Model: Stella-F1		Date: 21-Feb-02	No.: RH555001
Subject: Optional Printer Controller		Prepared by: A. Ishiyama	
From: Technical Services Dept., GTS Division			
Classification:	<input checked="" type="checkbox"/> Troubleshooting <input type="checkbox"/> Part information <input checked="" type="checkbox"/> Action required <input type="checkbox"/> Mechanical <input type="checkbox"/> Electrical <input type="checkbox"/> Service manual revision <input type="checkbox"/> Paper path <input type="checkbox"/> Transmit/receive <input type="checkbox"/> Retrofit information <input type="checkbox"/> Other (      )

Please note the following when installing the optional Printer Controller in the model S-F1.

Model: Model S-C1 Printer Option	Date: 11-May-04	No.: RB044011b
----------------------------------	-----------------	----------------

Subject: Printer Controller Firmware History		Prepared by: A.Ishiyama	
From: 1st Tech. Support Sec. Service Support Dept.			
Classification:	<input type="checkbox"/> Troubleshooting <input type="checkbox"/> Mechanical <input type="checkbox"/> Paper path <input type="checkbox"/> Other (      )	<input type="checkbox"/> Part information <input type="checkbox"/> El

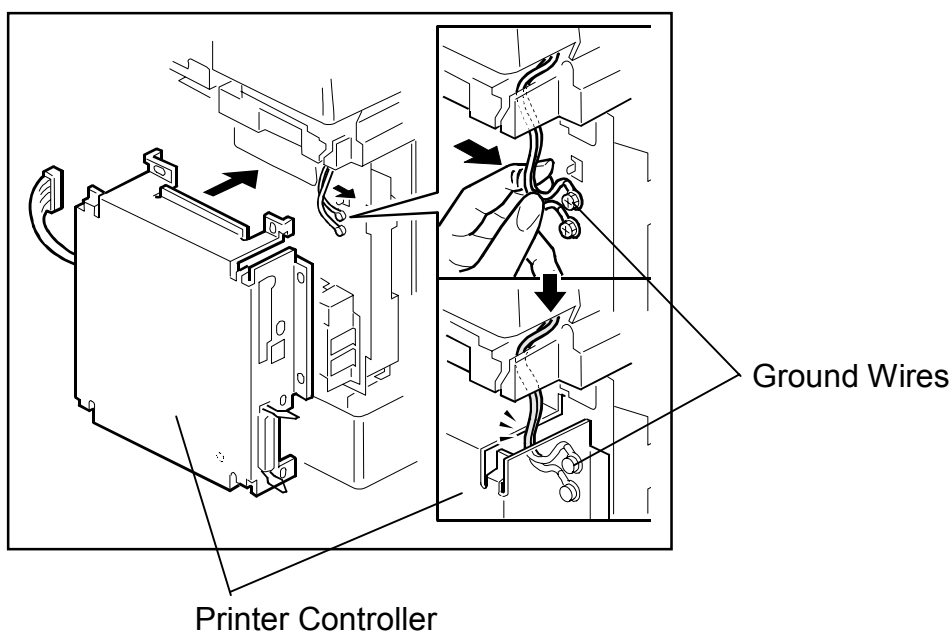
After installing the printer controller in Step 5 of the Installation Procedure, the ADF unit does not open all the way.

When the Controller was installed, the 2 ground wires were not led through the inlet (opening) in the upper right corner of the controller bracket, causing excess tension on the wires.

When installing the Printer Controller, be sure to set the wires into the opening in the upper right of the bracket as shown below. This will prevent excess tension on the wires and allow the DF to fully open.

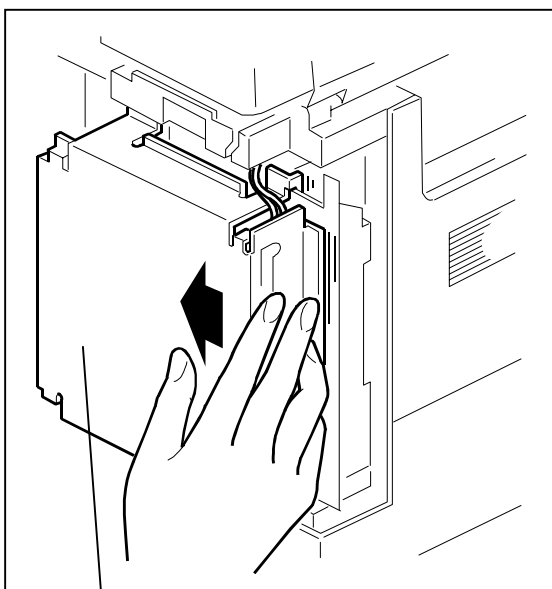
After installing the Printer Controller in Step 5 of the Installation Procedure, the 3 screw holes on the main face of the Rear Cover do not line up with the mainframe holes, making it difficult to reattach the cover.

When the Controller is attached slightly right of center, the width and circular (top) screw holes of the Rear Cover do not provide enough clearance for left/right cover adjustment, and the two contact one another.

When attaching the Controller, hold it flush against the left while tightening the bracket screws as shown in the illustration below.

The shape of the upper screw holes on the main face of the Rear Cover will be changed from circular to elliptical (running change) to allow for any necessary left/right adjustment.
